New Powder Container (NPC)  
Safety Analysis Report

NRC Docket No. 71-9294

Revised: January, 2001  
September, 2002  
October, 2006  
July, 2007  
October, 2007

## January, 2001 Revision to NPC SAR

Figure 2.1-1 - Sectional View of the GNF NPC Packaging

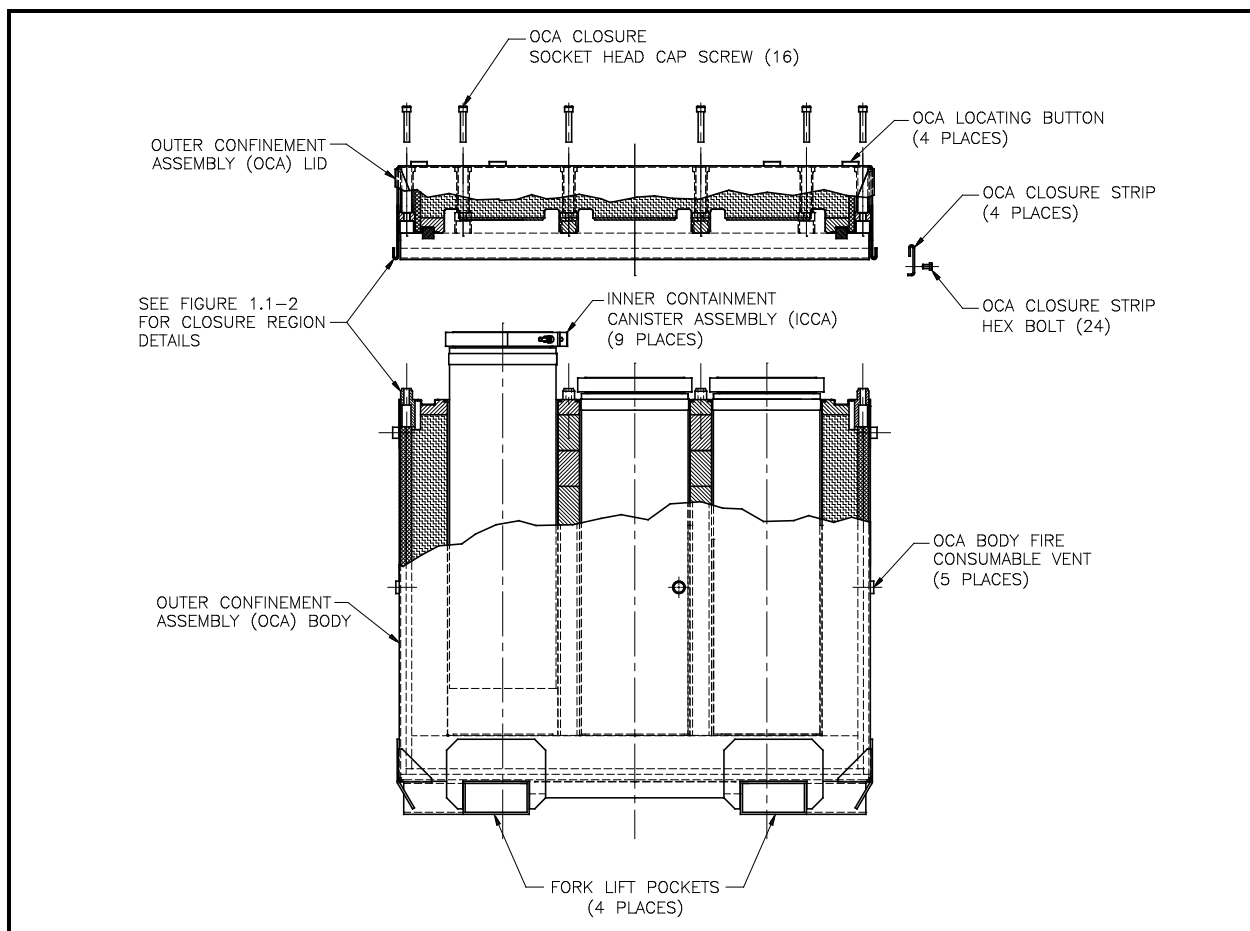
Page	Section	Explanation
2-2	Figure 2.1-1	Changed the wording “(Patent Pending)” to “Patent #6,166,391”.
2-6 through 2-7	2.5.2	Clarified the blocking and bracing for securing the package within the transport vehicle.
7-1	7.1	Removed the last sentence, because there is no longer a distinction between proprietary and non-proprietary drawings.
7-2	7.1.2, 3.	Clarified the loading procedure.
7-2	7.1.2, 4.	Added a new 4. to clarify the loading procedure.
7-2	7.1.2, 5. Through 9.	As a result of adding a new 4., the previous items 4. through 8. became 5. through 9.
7-2	7.1.2, 8.	Clarified wording.
7-3	7.1.3, 6.	Clarified the package preparation instructions and assured that they are consistent with Section 2.5.2.
7-3	7.1.3, 7.	Clarified the package preparation instructions and assured that they are consistent with Section 2.5.2.
7-3	7.1.3, 8.	Clarified the package preparation instructions and assured that they are consistent with Section 2.5.2.
